Basement Impact Assessment

35 Buckland Crescent

Addendum to Basement Impact Assessment report

Report reference JB15296.1, dated February 2014

LBMV architects have prepared drawings to reflect the minor material amendments sought for this project. Attached below is drawing 0043/A2002.

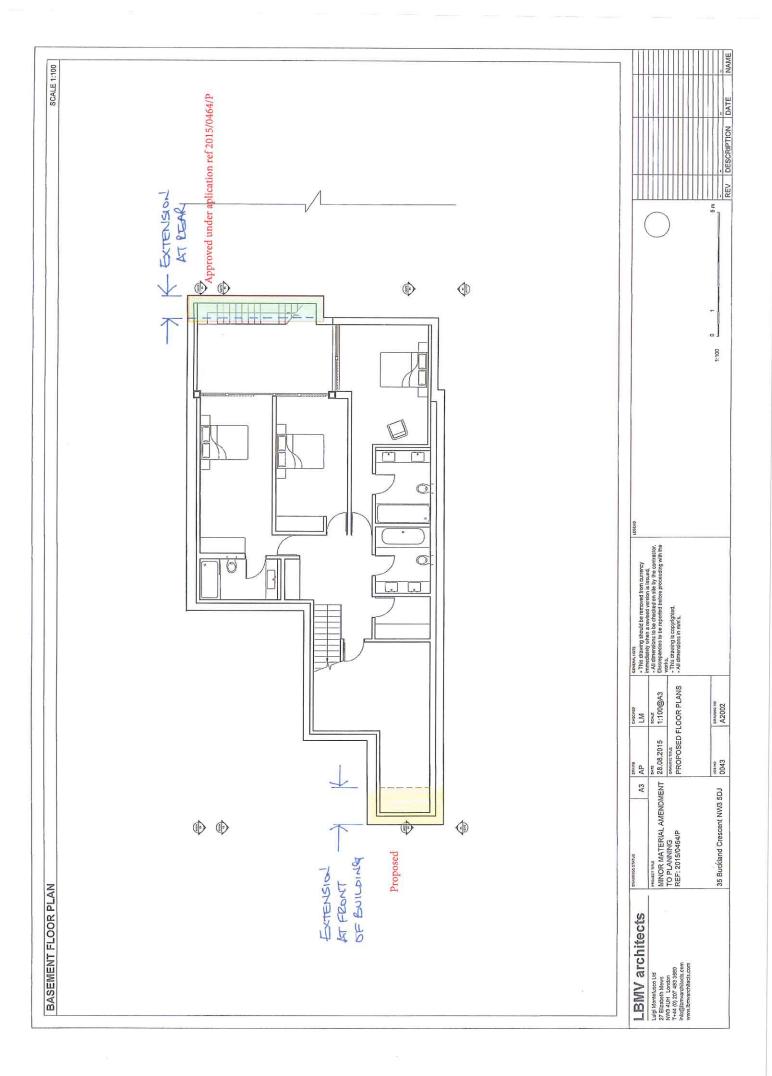
The proposed changes have been over marked in yellow to highlight the modest increase in the level of excavation being sought. These basically comprise a proposed extension of the basement at the front of the property to extend the proposed utility room. This extension is in the order of 1.7m (extended towards the road) by 3m width.

At the rear a proposal to increase the size of the lightwell adjacent to 33 Buckland Crescent, extending by 900mm further into the garden, of 5.4m width has been granted planning permission.
